RD Instruments
Acoustic Doppler Solutions

Field Service Bulletin FSB-132

Pressure Sensor Insert

Date: December 7, 2000

Figure 4. Close up view through microscope

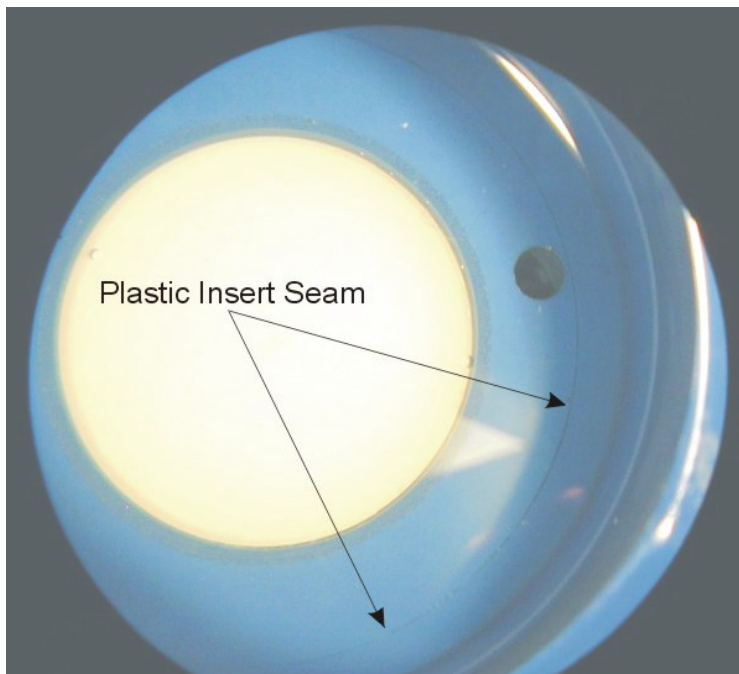
- d. Wipe the area under the cover disk with alcohol (best) or water. Look very carefully for any signs of a seam indicating that an insert was used. There may only be a slight difference in color between the transducer head and the insert. If available, use a strong light source and magnification.

- e. If the insert is on your ADCP, return the ADCP to RDI for a free warranty replacement. If you are not sure if the insert is installed, return the ADCP to RDI for a free inspection. If necessary, the ADCP will be replaced under warranty.
